Response to Comments of Public Hearing in San Jose, May 26, 2004 (PH-SJ001-054)

Response to Comments of James Webb, Jr., City of San Jose, High Speed Rail Authority, May 26, 2004 (Letter PH-SJ055)

San Jose to Merced
 Mount Diablo - Northern Merced
 Pacheco Pass - Merced Similar
 from Diridon Station, San Carlos St to The Alameda
 DM-1

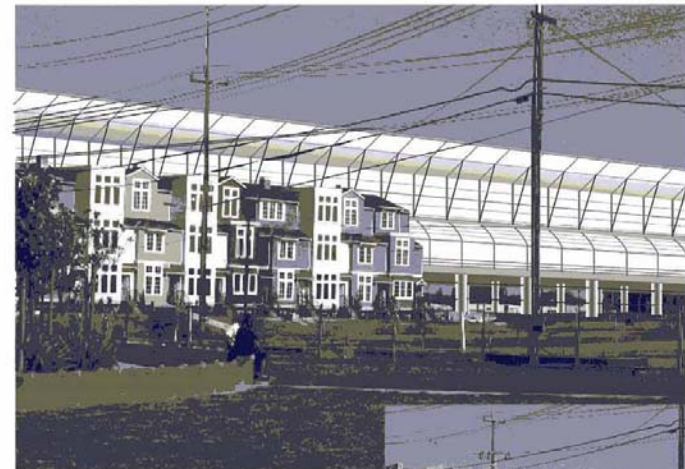
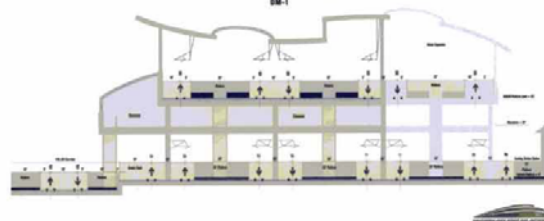
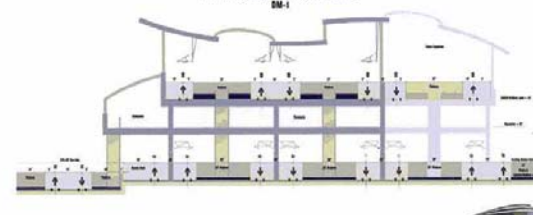
Caltrain at Grade
 Mezzanine at 30 feet
 High Speed Rail at 45 feet
 300,000 square feet of elevated platforms
 Elevated approach tracks

Caltrain at Grade
 Mezzanine at 30 feet
 High Speed Trains at 45 feet

Attachment to PH-SJ021-2. No response needed.

EXHIBIT 1

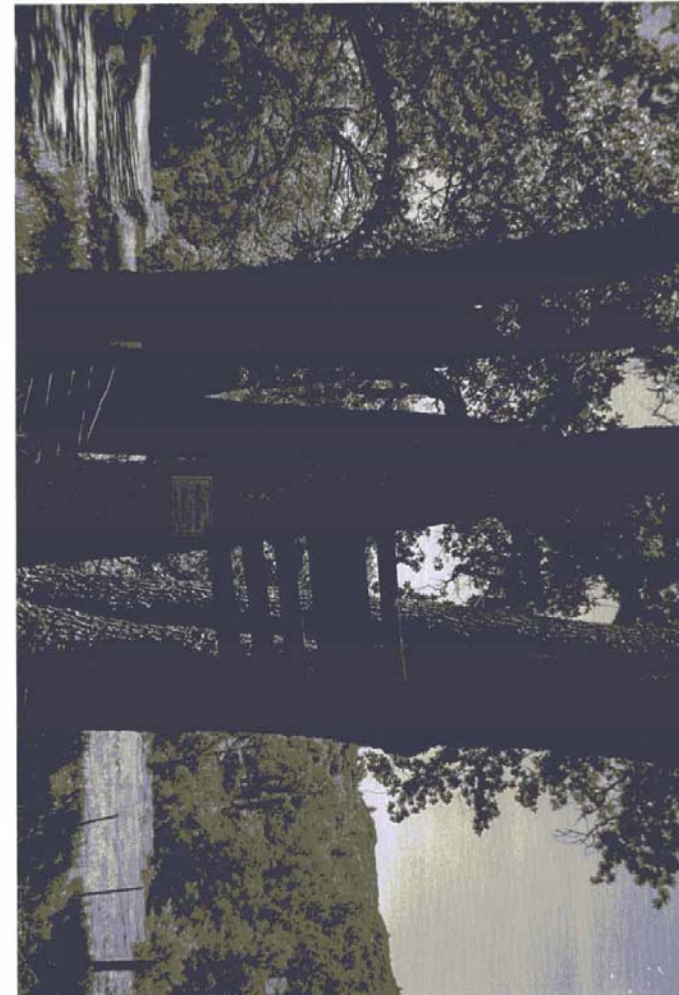
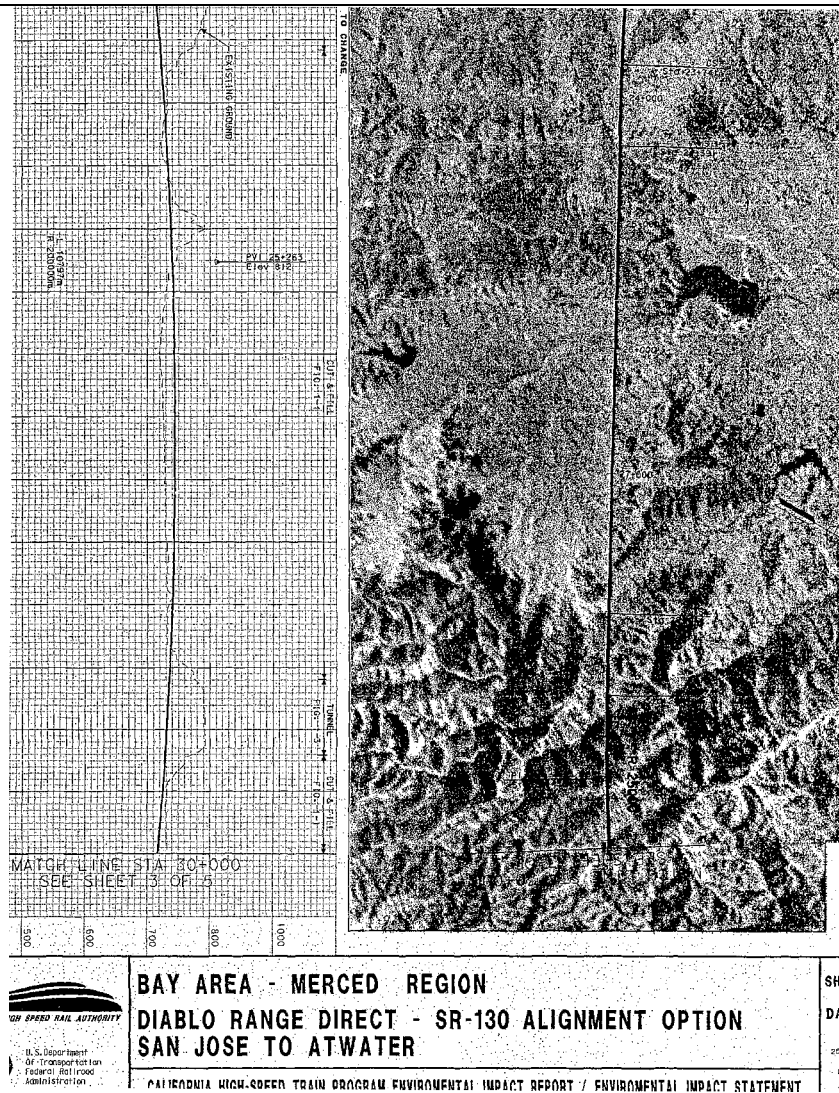
A high speed “bullet” train making many trips a day through the valley at grade elevation would be an environmental abomination. For your ready reference I have taken a few snapshots in the vicinity of the proposed alignment. See Exhibit 1, sheet 2 of 5 dated 6/6/02, which I obtained from HRA staff. These photos are attached to the written version of this statement, which has been passed out to each Board member.

Although shot with just a disposable camera on horseback, these photos of elk (Exh 2), antelope (Exh 3), wild turkeys (Exh 4), and even a coyote who posed for me along the roadside on the way in (Exh 5) convey a sense of the natural beauty and largely intact wildlife habitat that would be permanently and irretrievably damaged, if not utterly destroyed by the construction, maintenance and operation of a high speed train in this area. The photos show a small portion of the large elk herd that lives and thrives in the very same valley where the proposed train would bullet through many times each day. These grainy photos do not begin to portray the reality of

Read under PH-SJ039. Please see PH-SJ039 for responses. Please see standard response 6.3.1.
